Submit 1 Copy To Appropriate District State of New Mexico Office	Form C-103
District I – (575) 393-6161 Energy, Minerals and Natural Resources 1625 N. French Dr., Hobbs, NM 88240	Revised August 1, 2011 WELL API NO.
District II - (575) 748-1283	30-025-30536
811 S. First St., Artesia, NM 88210OIL CONSERVATION 2000 ConservationDistrict III - (505) 334-61781220 South St. Francis Dr.	5. Indicate Type of Lease
1000 Rio Brazos Rd., Aztec, NM 87410 District IV - (505) 476-3460 Santa Fe, NM 81/50/50 9 2018	STATE X FEE 6. State Oil & Gas Lease No.
1220 S. St. Francis Dr., Santa Fe, NM 87505	LG-6346
SUNDRY NOTICES AND REPORTS ON WELES CEIVED (DO NOT USE THIS FORM FOR PROPOSALS TO DRILL OR TO DEEPEN OR PLUG BACK TO A DIFFERENT RESERVOIR. USE "APPLICATION FOR PERMIT" (FORM C-101) FOR SUCH PROPOSALS.) 1. Type of Well: Oil Well X Gas Well Other	 7. Lease Name or Unit Agreement Name STATE 12 "AA" 8. Well Number

2. Name of Operator	9. OGRID Number
CIMAREX ENERGY CO. OF COLORADO	162683
3. Address of Operator 600 N. MARIENFELD, SUITE 600, MIDLAND, TEXAS 79701	10. Pool name or Wildcat LOVINGTON PENN, N.E.

4. Well Location	
Unit Letter I : 1980 feet from the SOUTH line and 810 feet from the EAST line

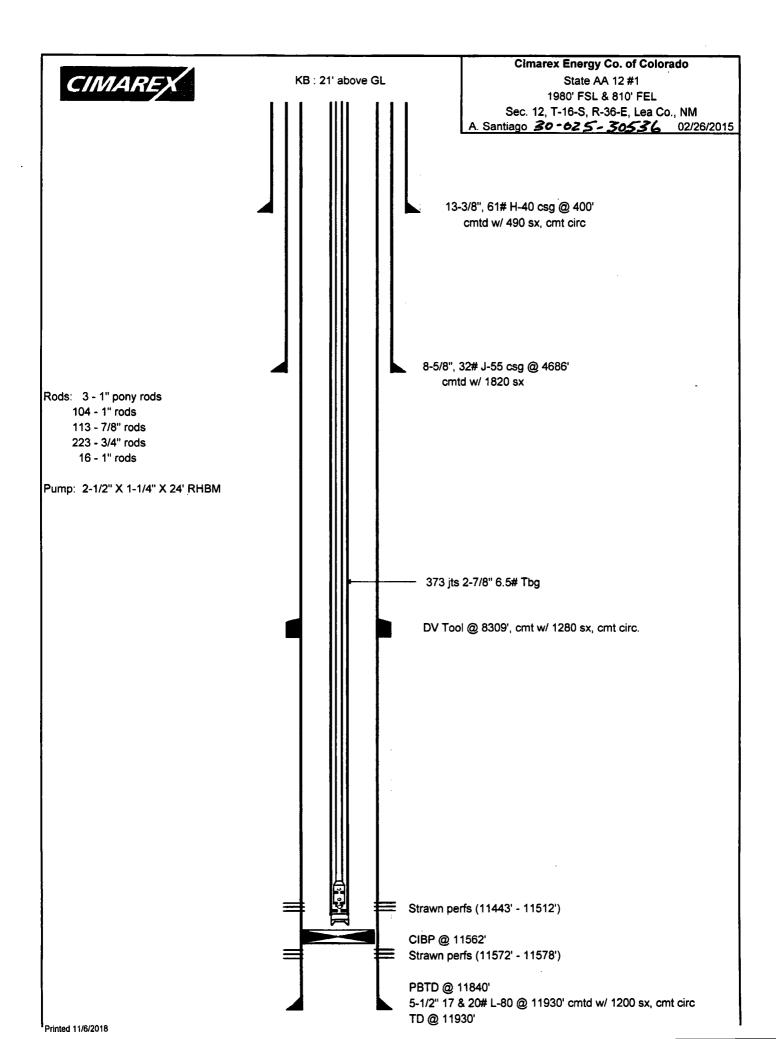
13. Describe proposed or completed operations. (Clearly state all pertinent details, and give pertinent dates, including estimated date	
of starting any proposed work). SEE RULE 19.15.7.14 NMAC. For Multiple Completions: Attach wellbore diagram of	
proposed completion or recompletion. Ressure Test CSg.

9) DIG OUT X CUT OFF WELLHEAD 3' B.G.L.; WELD ON STEEL PLATE TO CSGS. X INSTALL DRY HOLE MARKER.	
	See Attached
Spud Date: Rig Release Date:	
	Conditions of Approval
	•••
I hereby certify that the information above is true and complete to the best of my knowled	ge and belief.
SIGNATURE SIGNATURE AGENT	DATE: 11/06/18
Type or print name: DAVID A. EYLER E-mail address: DEYLER@MILAGRO-RES.COM PHONE: 432.687.3033	
For State Use Only	
APPROVED BY: Markethilter TITLE P.E.S. Conditions of Approval (if any):	DATE 11/13/2018
